UNITED STATES PATENT AND TRADEMARK OFFICE

APPLICATION NO.	FILING DATE	FIRST NAMED INVENTOR	ATTORNEY DOCKET NO.	CONFIRMATION NO.
09/585,682	06/01/2000	Kei-Yu Ko	3526.2US(97-1136.2)	7481

Office Action Summary

DETAILED ACTION

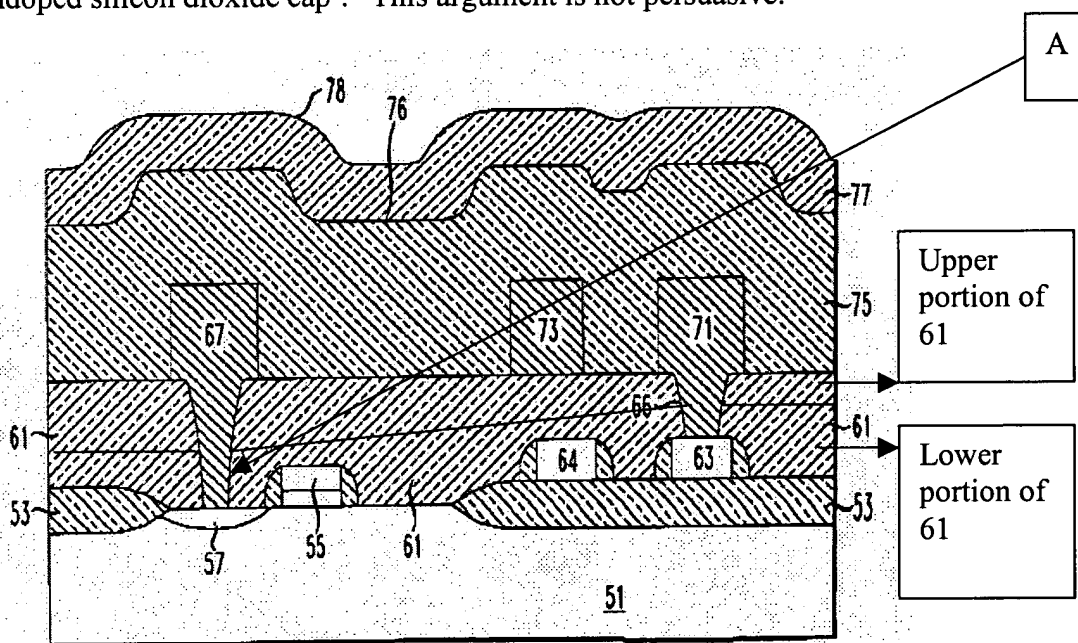
On page 6, applicant argues "it is respectfully submitted that the windows 66 and 67 of the semiconductor device described in Cargo and shown in Figs. 2, 4 – 6, and 8 thereof do not include sidewalls which extend 'substantially perpendicular' relative to the substrate 51 thereof. To the contrary, FIGs. 2, 4 – 6, and 8 of Cargo depict the windows 66 and 67 as having curved sidewalls which are oriented at a variety of nonperpendicular angles relative to the substrate 51." This argument is not persuasive. Since the term "substantially perpendicular" is broad language, any angle that is almost perpendicular to the semiconductor substrate read as "substantially perpendicular". Therefore, the term "substantially perpendicular" clearly does not structurally distinguish over Cargo et al.

Furthermore, applicant argues “it is respectfully submitted that the description of Cargo (see FIGS. 2, 4-6, and 8) is limited to a semiconductor device which includes windows 66 and 67 with sidewalls that extend continuously and in uninterrupted fashion through dielectric 61, including both the upper doped silicon dioxide portion thereof and the lower, undoped silicon dioxide portion thereof. Thus, Cargo does not expressly or inherently describe that any portion of any of the sidewalls of window 66 or 67 terminates at an undoped silicon dioxide section of dielectric 61. As such, Cargo neither expressly nor inherently describes ‘at least one contact aperture’ with ‘at least one sidewall’ that includes ‘at least a portion’ which ‘terminat[es] at [an] undoped silicon dioxide cap’.” This argument is not persuasive.

Since the point (A in the above figure) clearly shows the sidewall (at the right side of the element 67) of the contact aperture terminates at the side surface of the undoped silicon dioxide cap (Lower portion of 61), hence Cargo et al. meets the limitation, at least one contact aperture with at least one sidewall that includes at least a portion which terminates at an undoped silicon dioxide cap, as required in claims 1 and 6.

For the above reasons, the rejection is maintained.
